REQUEST FOR INVITATION TO BID #2026-02
CAMPUS ELECTRICAL DISTRIBUTION
ADDENDUM III
March 4, 2026

1. **Exhibit A – Plans (v.02162026)** shall be amended to include the attached Revised C1.1 – C1.4.

ELECTRICAL PAD PROPOSED SITE PLAN
OREGON INSTITUTE OF TECHNOLOGY
3201 CAMPUS DR.,
KLAMATH FALLS, OREGON 97601

ELECTRICAL PAD WALL SECTIONS
OREGON INSTITUTE OF TECHNOLOGY
3201 CAMPUS DR,
KLAMATH FALLS, OREGON 97601

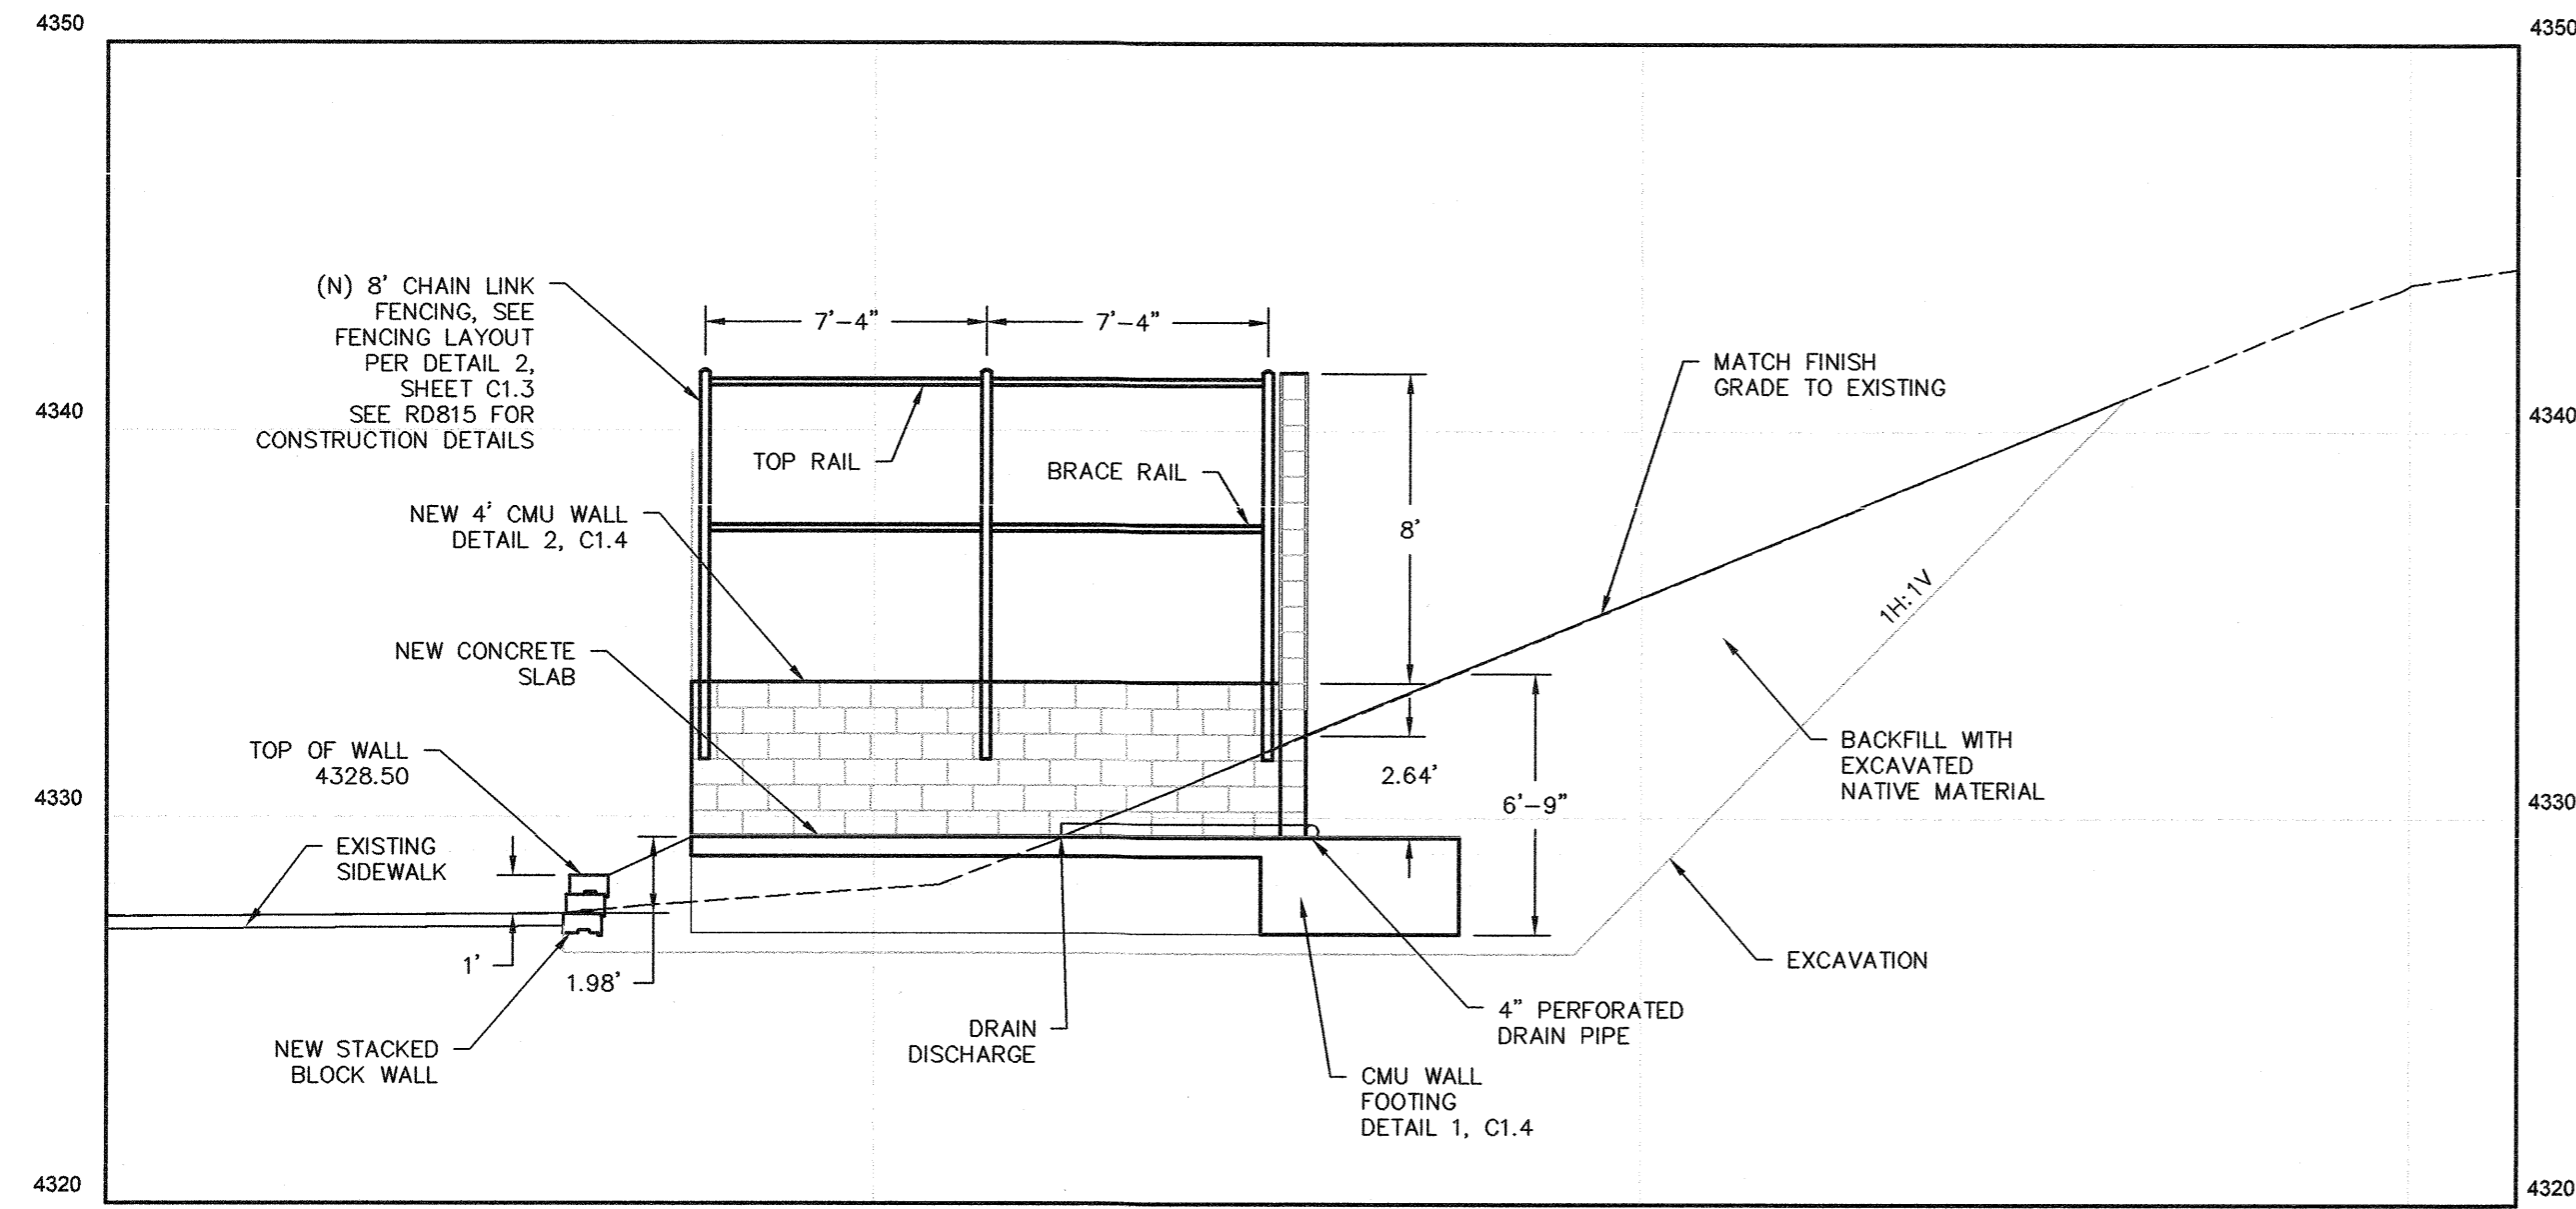
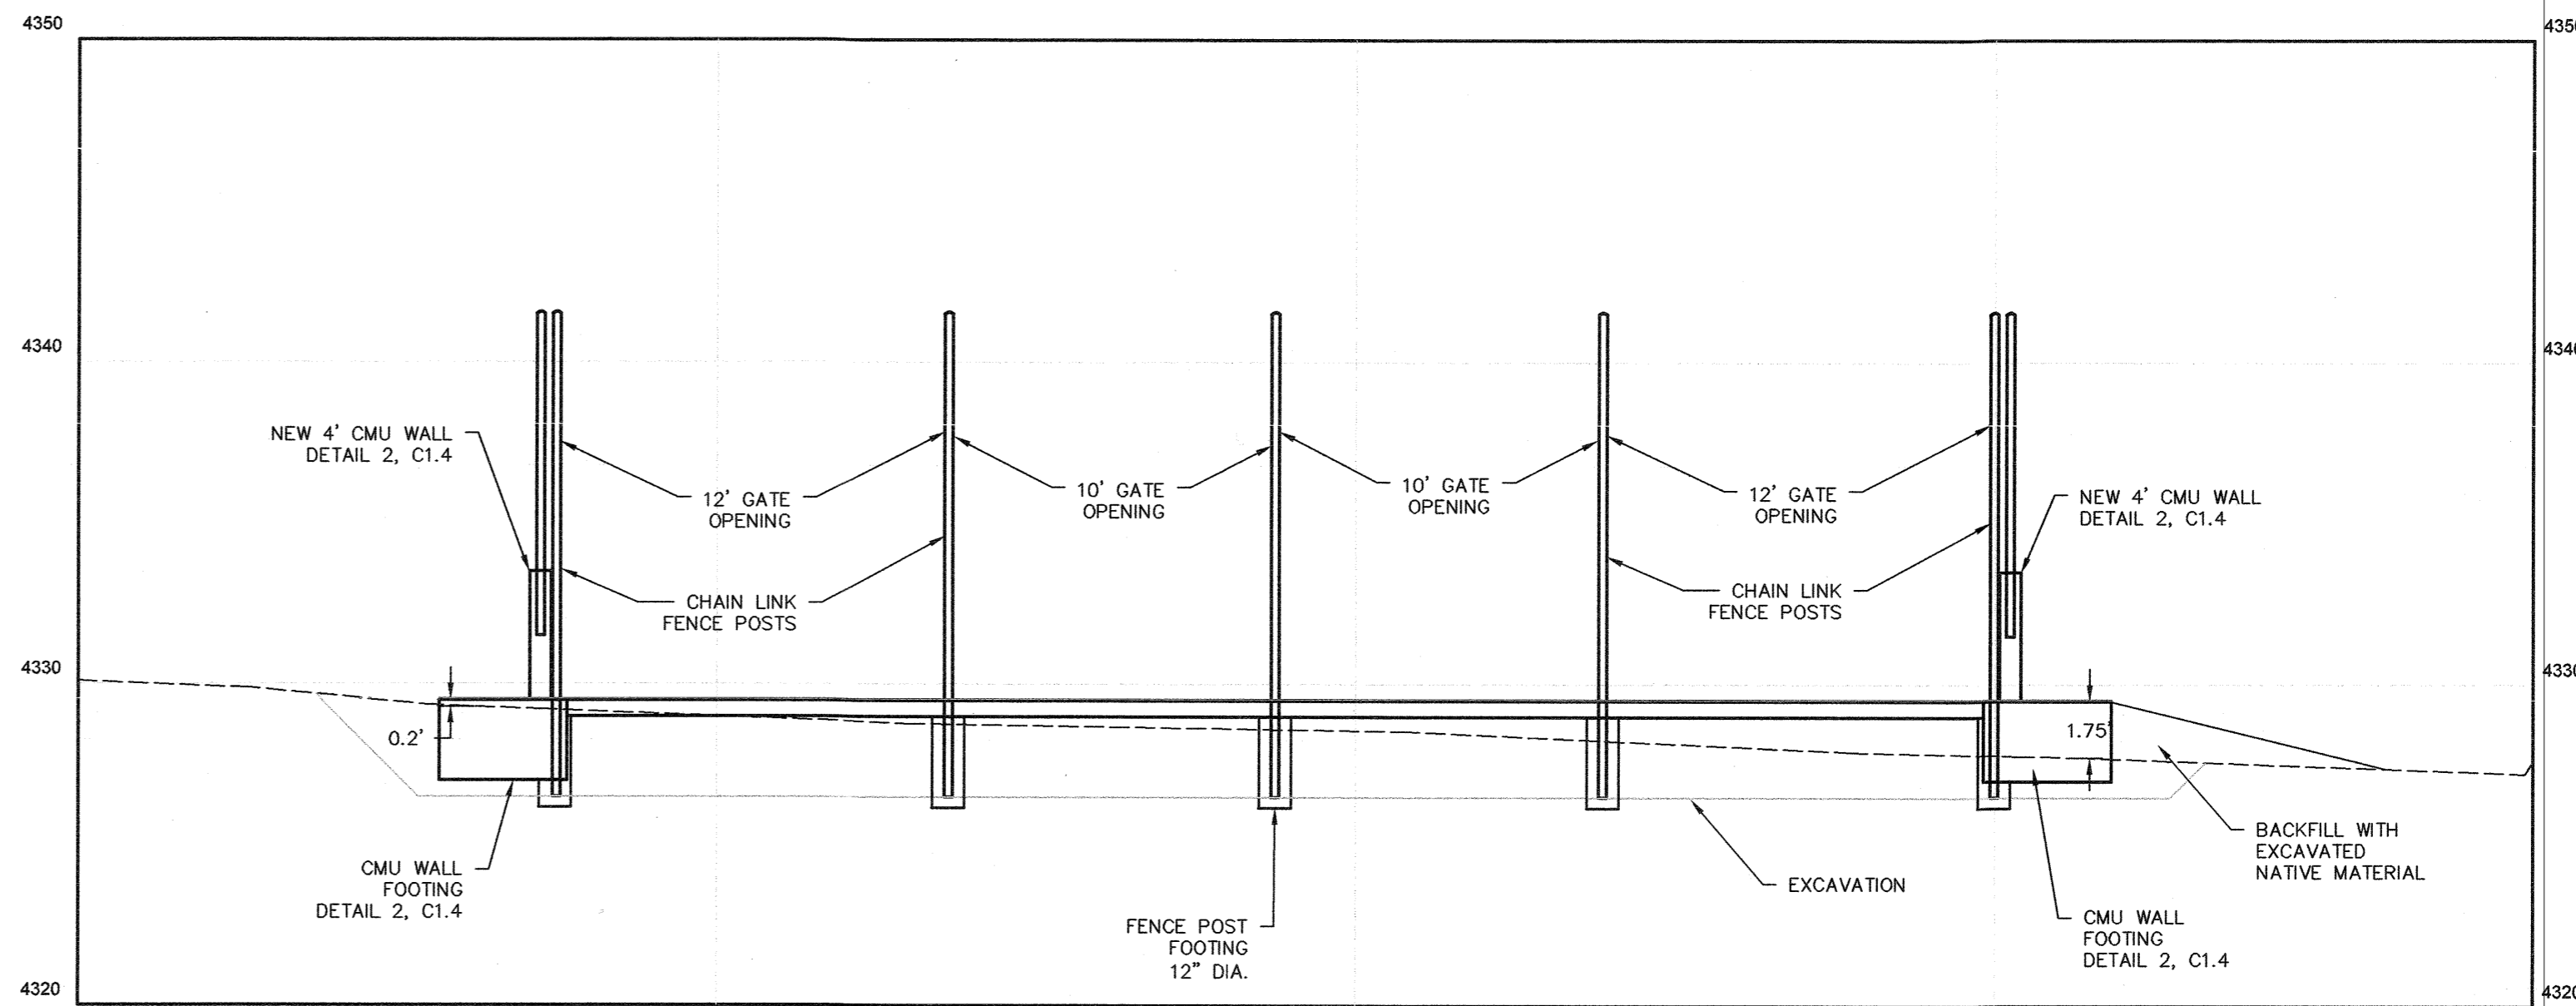
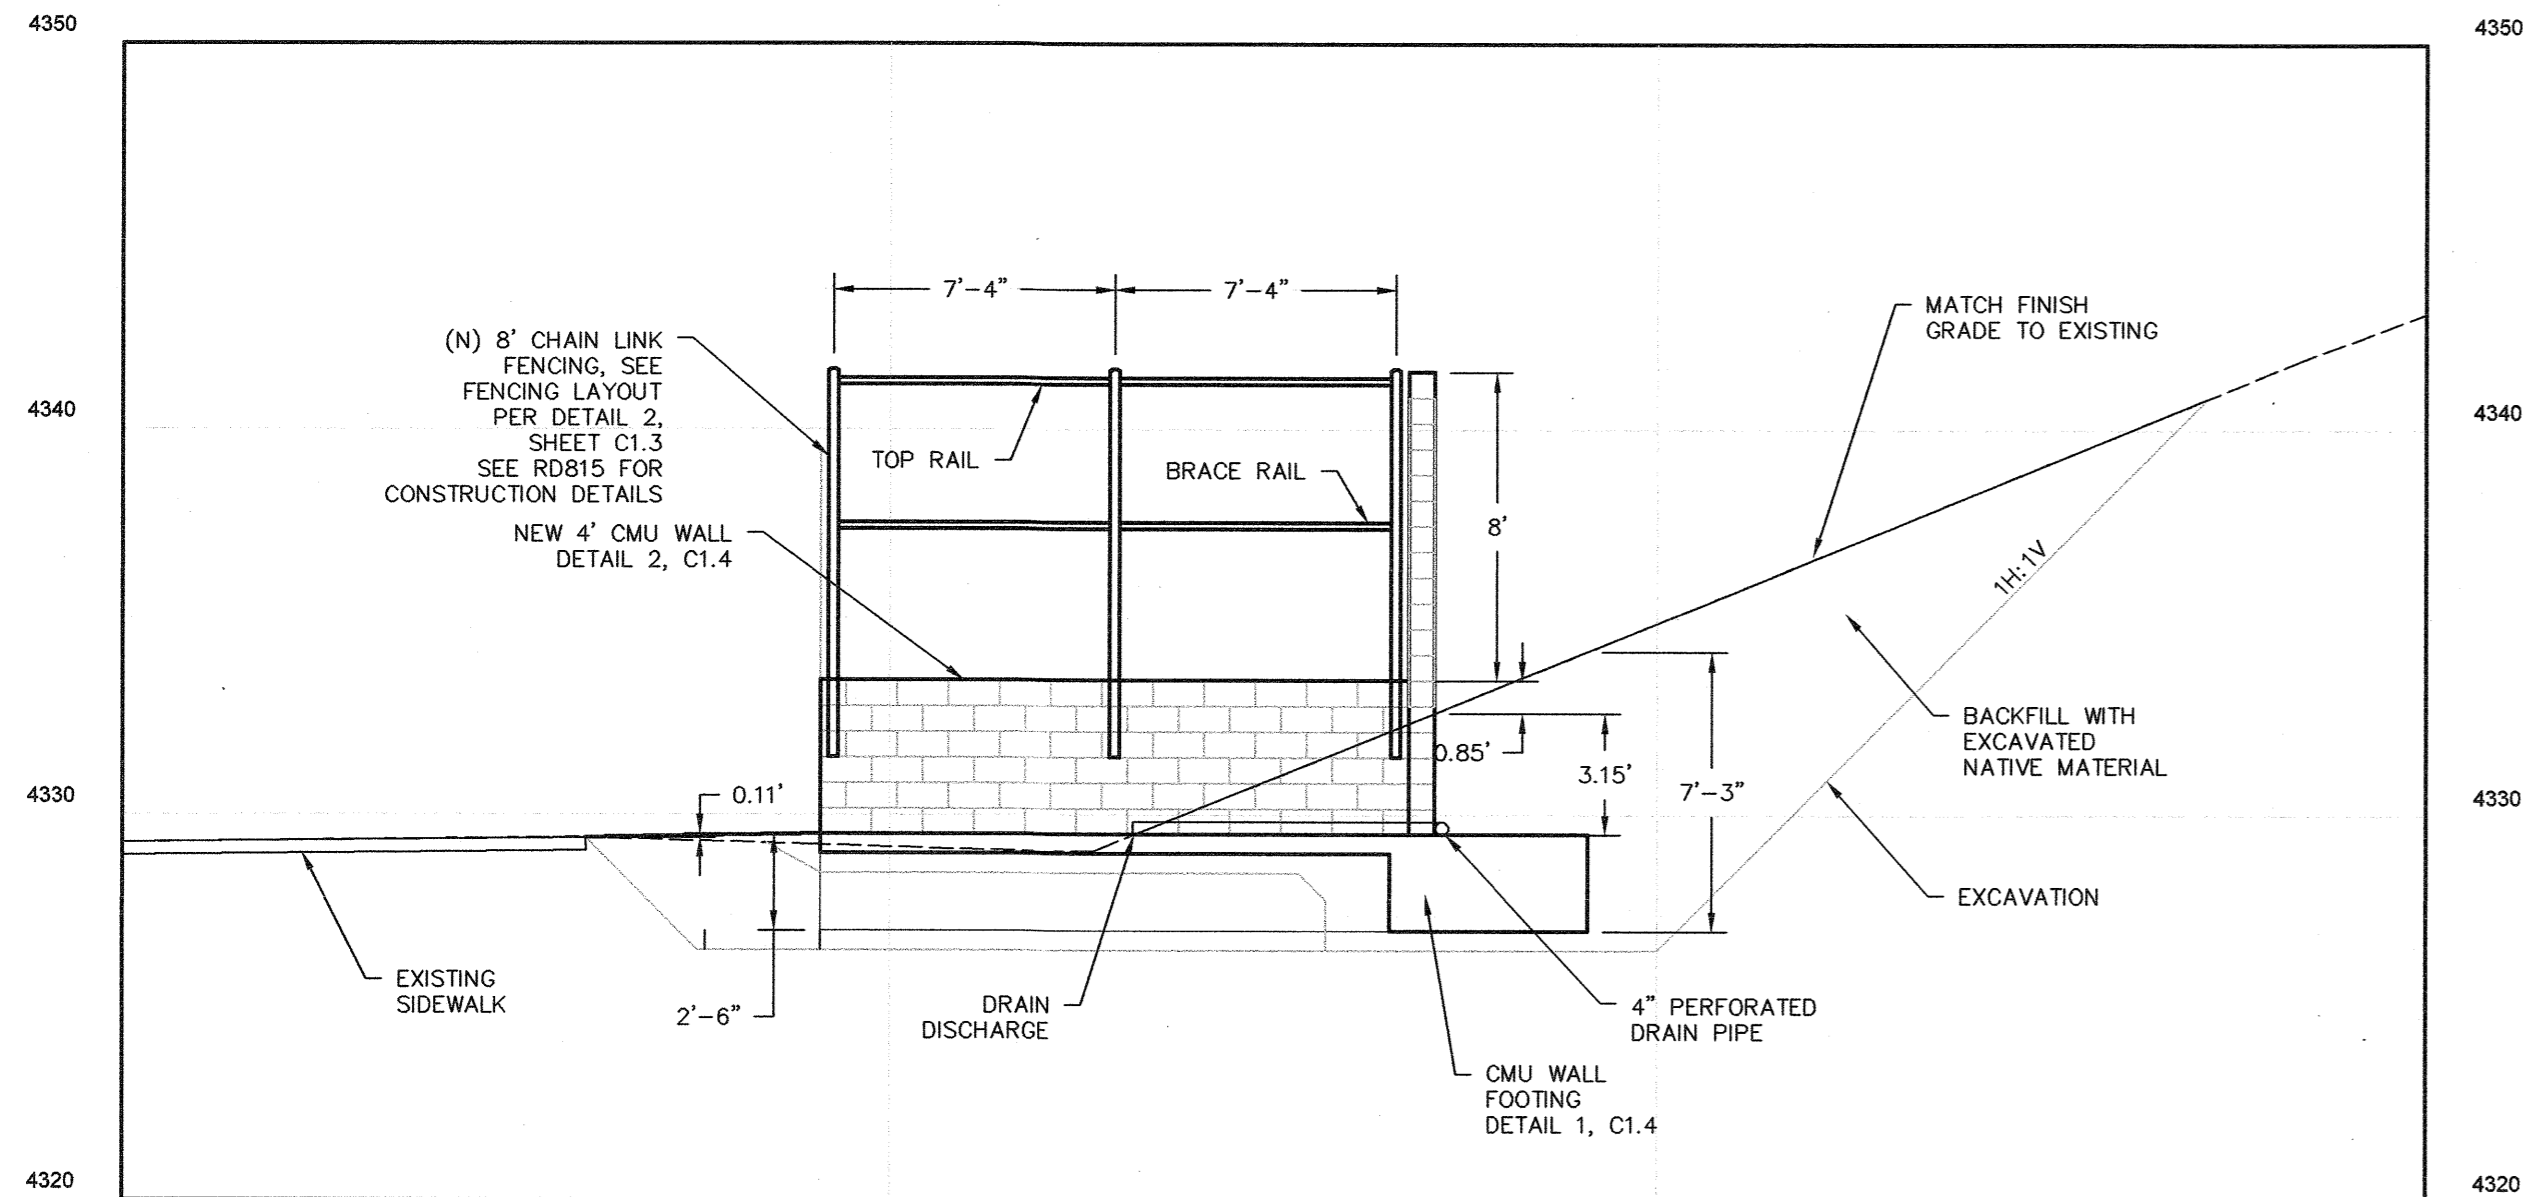
DATE	REVISION DESCRIPTION	BY
8/2/25	FIX TEXT	R.C.
3/1/26	LOWER CMU WALL, REMOVE COVER	R.C.
